Work Order ID 96721

Item ID: D206-667-103

Item Name: Crosstube Fwd

| DESIGN |  | DART AEROSPACE LTD HAWKESBURY, ONTARIO, CANADA DRAWING NO. REV. 0 D206-667-143 SHEET 1 OF 1 TITLE SCAL CROSSTUBE ASS'Y (206L HIGH FWD) NT | |

ECO #11-615
11.07.26
UNDER REVIEW
CP 1206.13

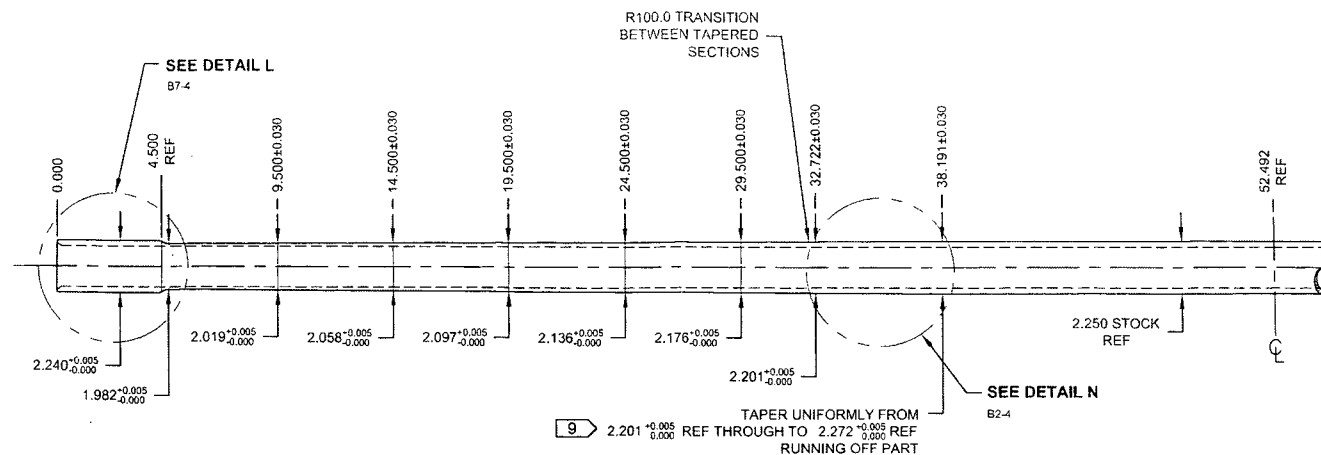
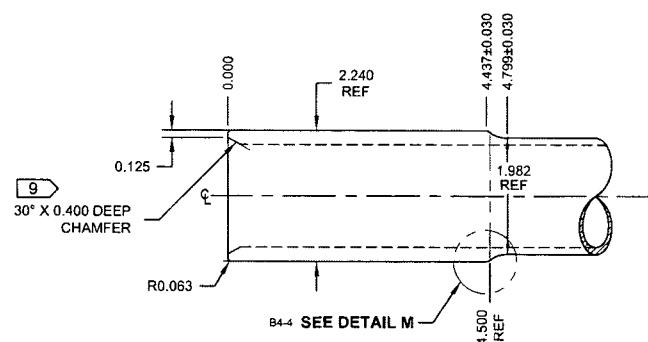
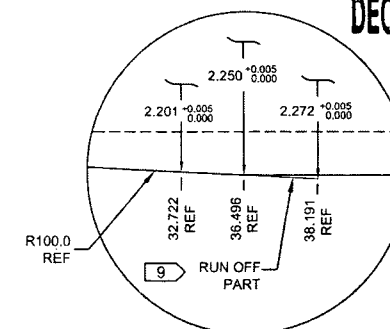
REPLACE MAGNOBOND WITH PROSEAL.

NOTE 12 & 15, SHEET 1 IS AMENDED AS FOLLOWS:

- 12) TO INSTALL D2891-1 SUPPORT: ABRASE MATING SURFACE OF SUPPORT AND CROSSTUBE WITH 180-GRIT SANDPAPER AND REMOVE RESIDUE WITH MEK (OR EQUIVALENT). APPLY A 0.04" TO 0.07" THICK LAYER OF PROSEAL 890 CLASS B-2 (OR AMS-S-8802 CLASS B-2) SEALANT TO MATING SURFACE OF SUPPORT.
- 15) TORQUE CLAMPS 80 TO 100 IN-LB. ENSURE AT LEAST 1.5 THREADS SHOWING IN SAFETY AND THAT NUT HAS NOT BOTTOMED-OUT AFTER TORQUING. **PRIOR TO PACKAGING, RE-CHECK TORQUE ON CLAMPS AFTER PROSEAL 890 SEALANT HAS CURED FOR 72 HOURS.**

RELEASED
12.08.17
ECN 12-631

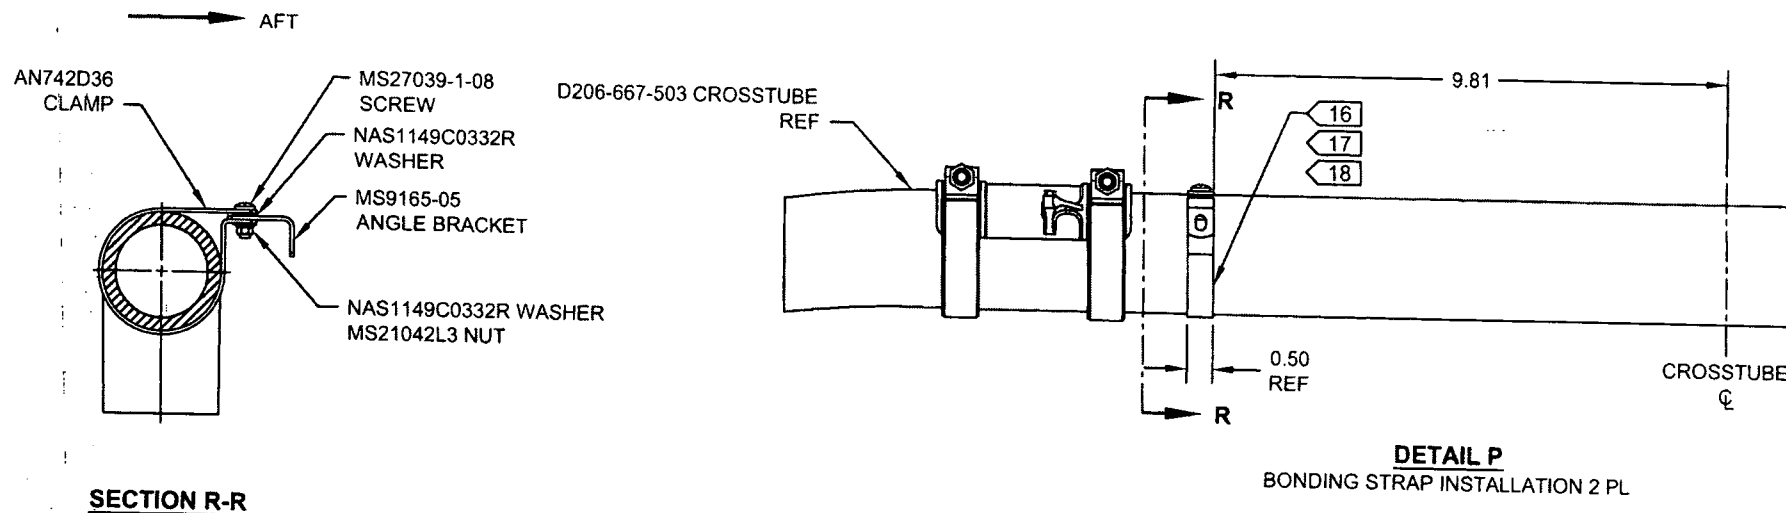
ADD ELECTRICAL GROUNDING STRAP

- 16) MASK AREA UNDER CLAMP PRIOR TO PAINTING
- 17) SEAL EDGES WHERE AN742D36 CLAMP MEETS WITH THE CROSSTUBE USING SIKAFLEX-241/-291 OR MIL-S-8802 CLASS B2 OR PROSEAL 890 SEALANT
- 18) PERFORM RESISTANCE CHECK TO ENSURE MAX RESISTANCE IS 10 MILLIOHMS
